## Memorandum Department of Planning & Public Works

**RE:** **P.Z. 10-2009 84 Lumber (MASE LLC):** A request for a change of zoning from "C-8" Planned Commercial District to "PI" Planned Industrial District for a 7.42 acre tract of land located south of Interstate 64/Highway 40 and East of Long Road at 17519 Chesterfield Airport Rd. (17U510073).

## **Planning Commission Staff Report**

**Petition:** P.Z. 10-2009 84 Lumber (MASE LLC)

LOT 1 OF 84 LUMBER SUBDIVISION  
PRELIMINARY DEVELOPMENT PLAN - REZONING  
BASE MAP # 17U

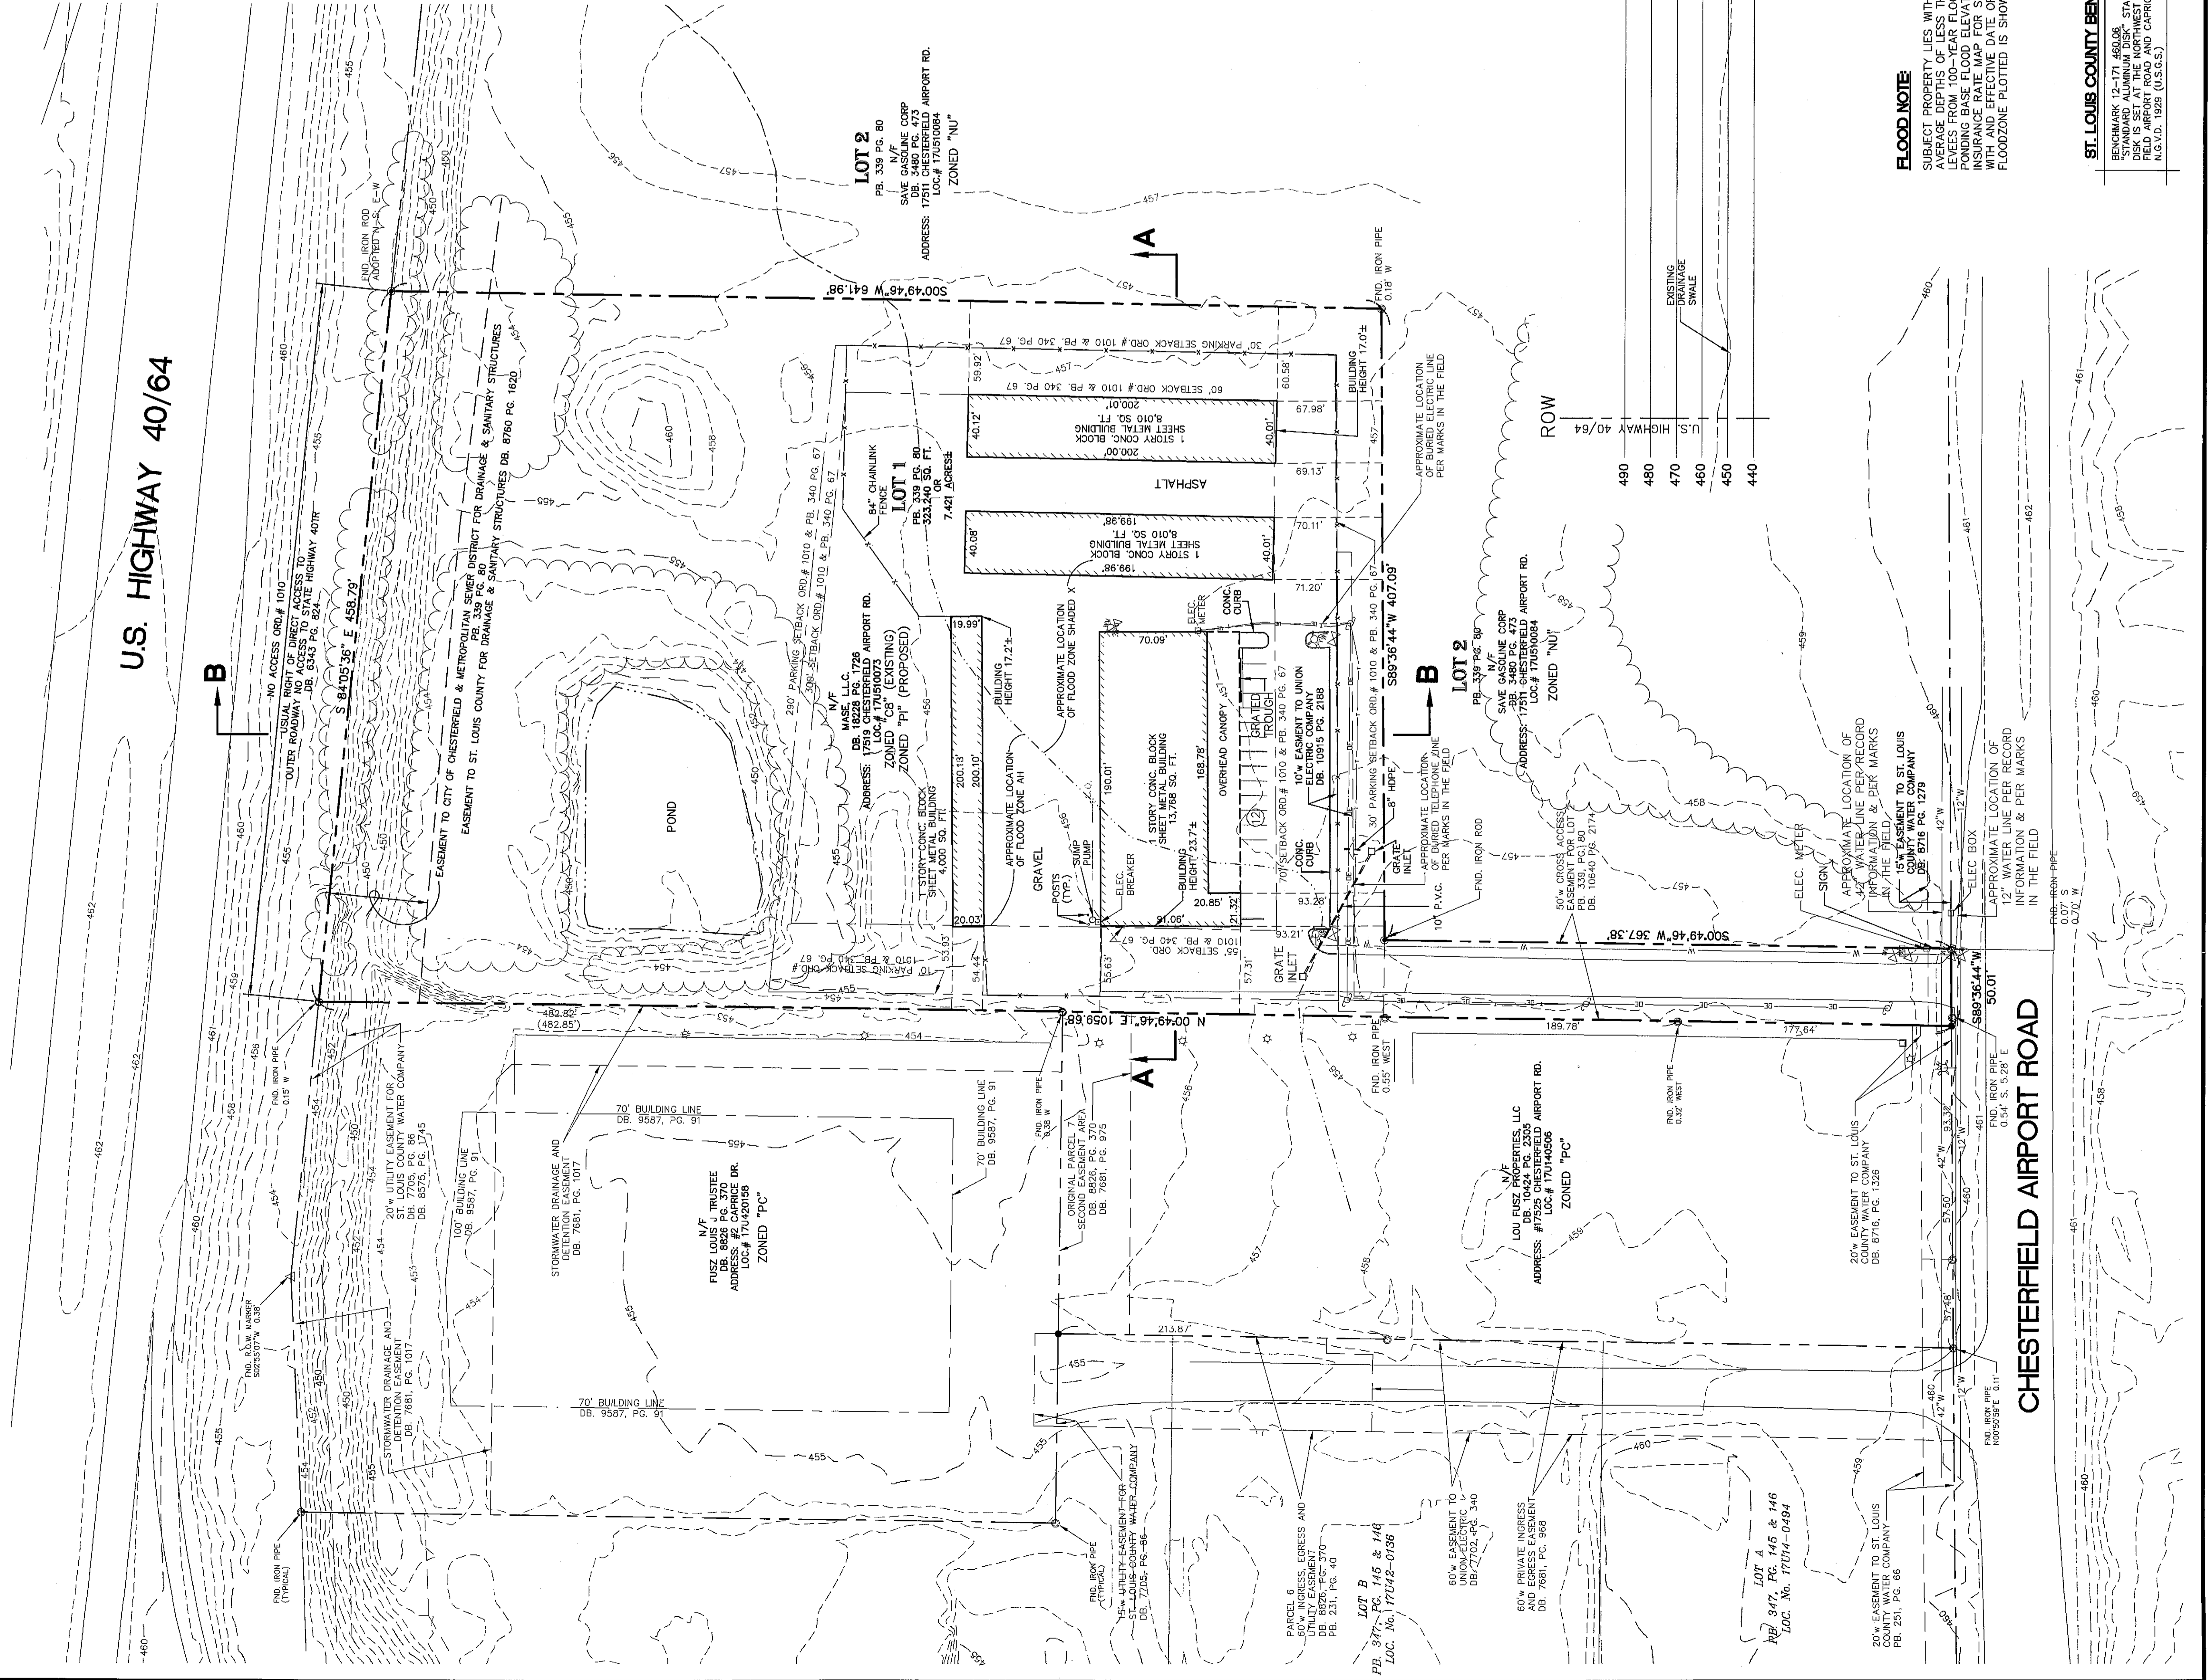
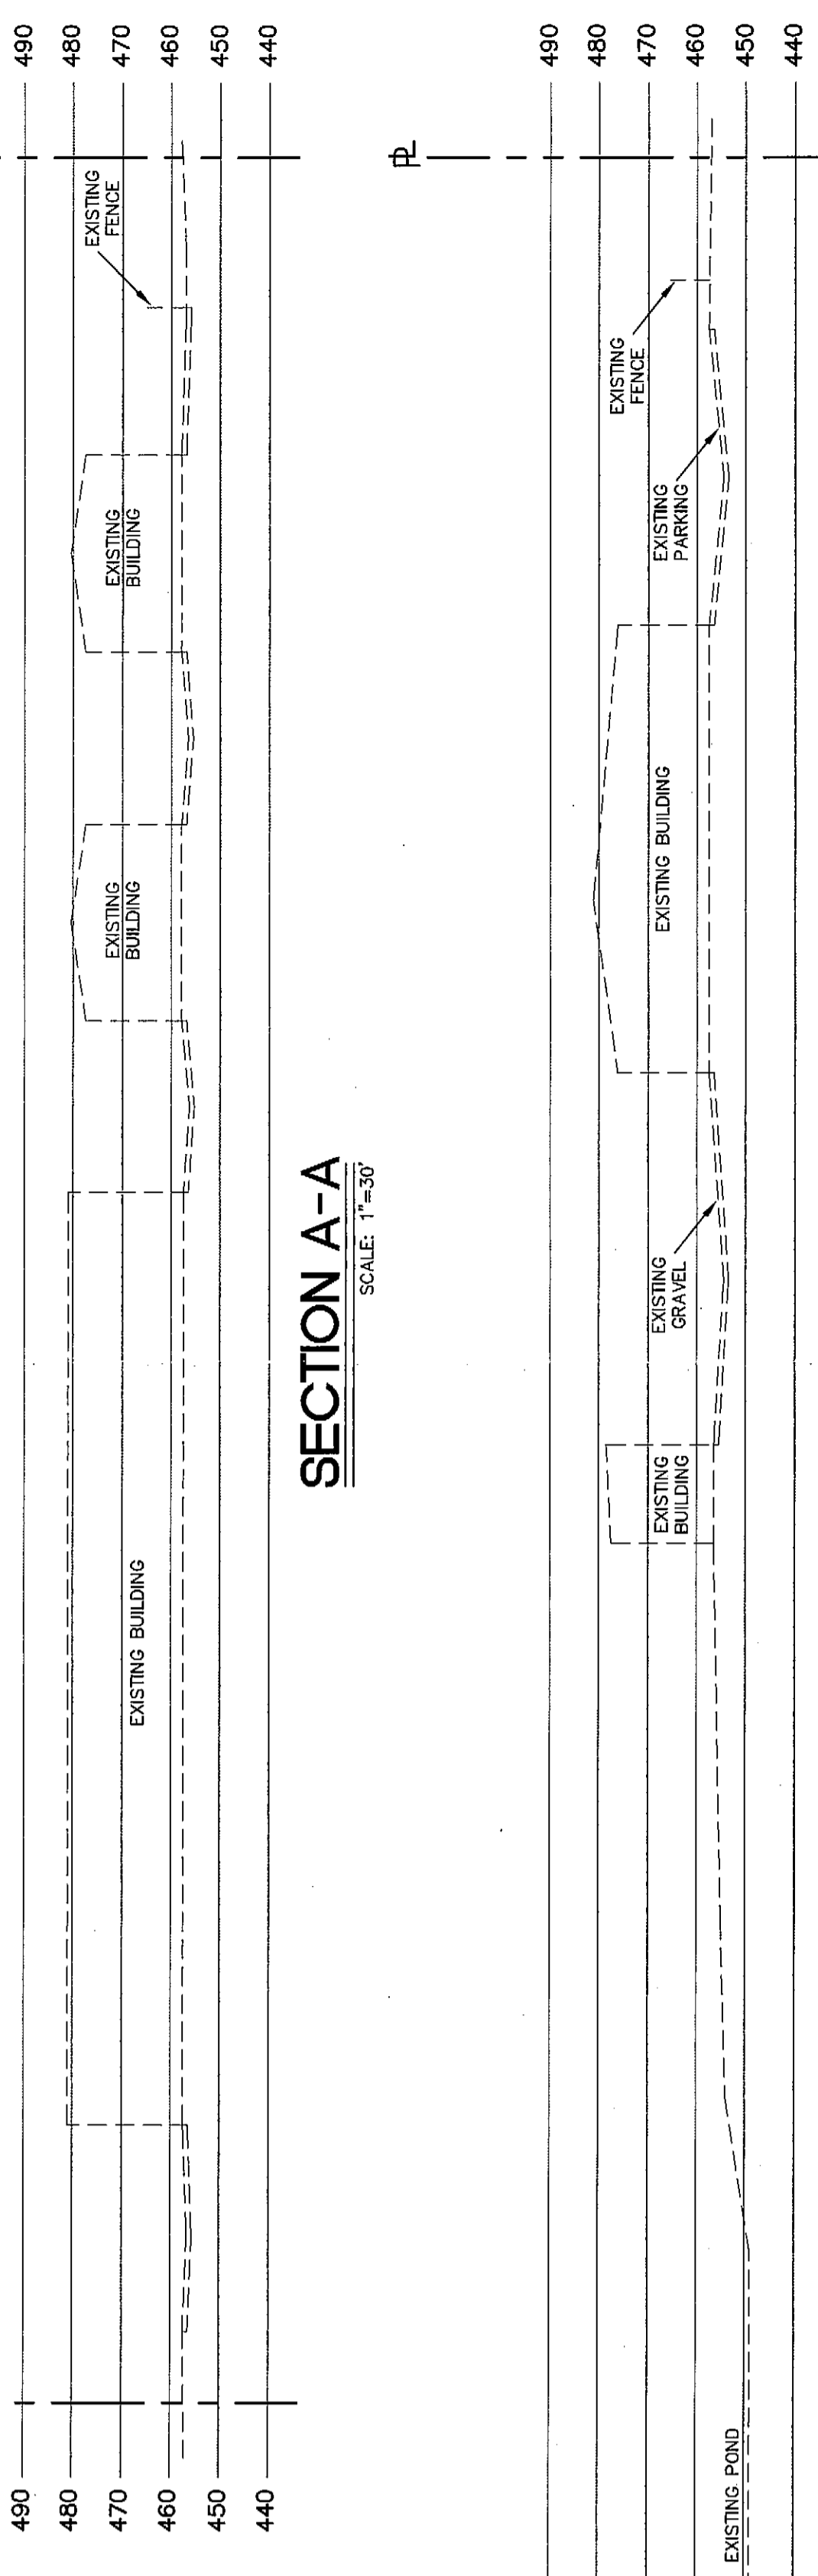
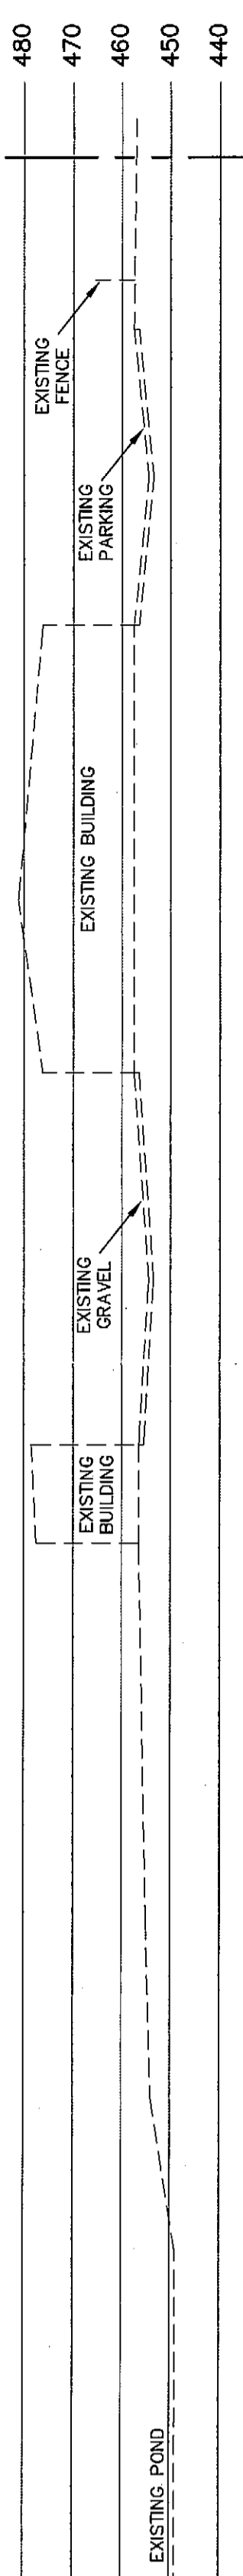
10. Revise the location map on the Preliminary Plan to show the correct parcel.
11. The Missouri Department of Transportation has submitted the following comments:

10. Revised site plan attached.

11 - 12. Petitioner has contacted the MO Department of Transportation and Chesterfield Public Works, and has revised the site plan to show the proposed future required ROW. Additionally, Petitioner will otherwise meet all requirements of MoDOT, Chesterfield
